TECHNICAL NOTE 1

| SUBJECT: | A14 NMU Routes BN18 and BN22 Safety Reviews | | |
| PROJECT: | A14 NMU Bridges | AUTHOR: | [REDACTED] |

Figure 6- Swavesey South Location Plan

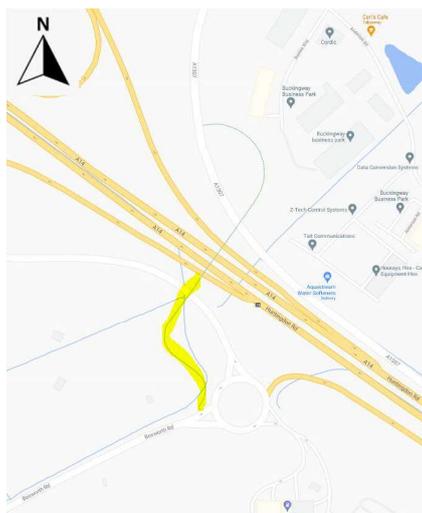
On the Swavesey south route, the gradients are more gentle and the route leads to an uncontrolled crossing via a 90-degree bend. At the tie in to Boxworth Road, there are wayfinding signs for pedestrians, cyclists and horse riders, but the shared signs leading to the NMU bridge is only signed for pedestrians and cyclists. It is therefore unclear whether horse riders are expected to use the bridge.

Cyclists descending the ramp at Swavesey south have good visibility to approaching cyclists/ pedestrians and will be slowing down to the crossing due to the 90-degree bend. The risk of collision with other pedestrians/cyclists and vehicles at this location is low.

It is recommended that the chicane barrier arrangement at this location is removed. It is also recommended that a form of vehicle access control is provided to prevent unauthorised vehicles from accessing the NMU route.

Figure 9 – Bar Hill North Location Plan

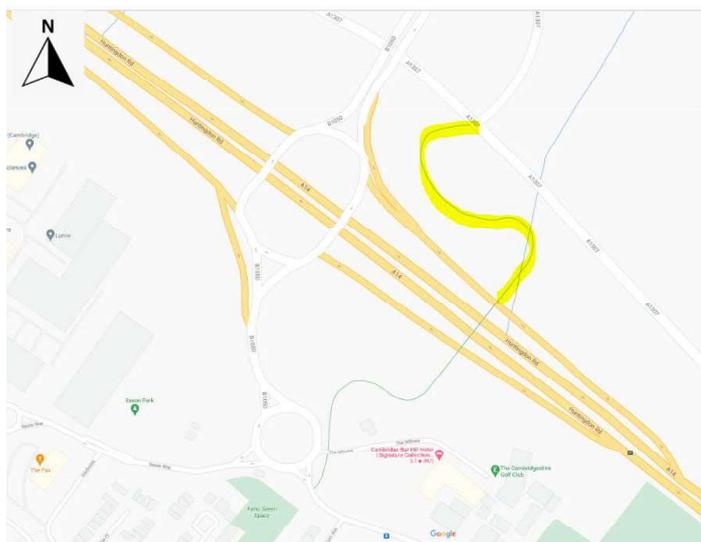
The NMU route over the A14 at its northern end joins the existing road (A1307) parallel to the A14 via a controlled crossing.

The slope on the northern approach ramp is gentle and unlikely to encourage higher cyclist speeds. The visibility to other approaching cyclists/ pedestrians is generally good. There is a wide verge serving as a buffer zone between the NMU route and the carriageway. The risk of speed and collisions with other pedestrians/cyclists or vehicles at this location is low.

It is recommended that the chicane barrier arrangement at this location is removed. It is also recommended that a form of vehicle access control is provided to prevent unauthorised vehicles from accessing the NMU route.

Figure 12 – Bar Hill South Location Plan

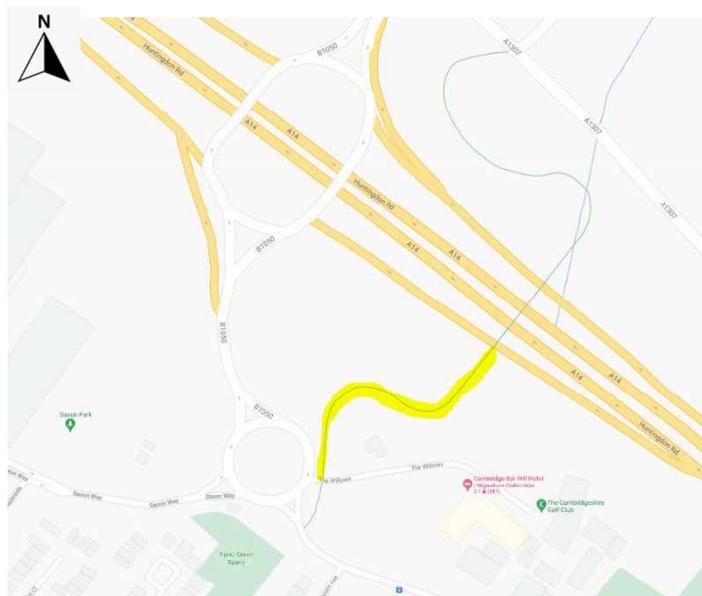
South of the NMU bridge, the alignment of the route follows a series of horizontal curves and gradients along this section appear to be steep (LTN 1/20 recommends a desirable maximum length of 30m for a 5% gradient). The edge of the NMU route is protected by a high fence infilled with mesh. Visibility along this section of the route is restricted by the horizontal curvature and fence. There is no visibility to other approaching cyclists/pedestrians or horse riders and there is an increased of conflict between cyclists and pedestrians/other cyclists and horse riders. Any conflicts between cyclists/pedestrians/horse riders is likely to occur within this section.

Visibility as the route approaches the Willows is generally good although it is partially obstructed by a large sign and overgrown vegetation in the northern verge of The Willows.

At the location of the southern barrier, cyclists will generally have good forward visibility to traffic however visibility to vehicles exiting The Willows is obstructed by the hotel sign and overgrown vegetation. Risk of collision with vehicles or other cyclists/pedestrians is low.

- The chicane barrier arrangement is removed.
- A form of vehicle access control is provided to prevent unauthorised vehicles from accessing the NMU route.
- The hotel sign in the northern verge of The Willows is set further back and overgrown vegetation cut back to improve visibility to vehicles exiting The Cambridge Bar Hotel.
- Cycle logos are installed on the outside of the bend on the downward grade where visibility is poor to encourage cyclists to keep to the edge of the NMU route thereby minimising conflict with other users.
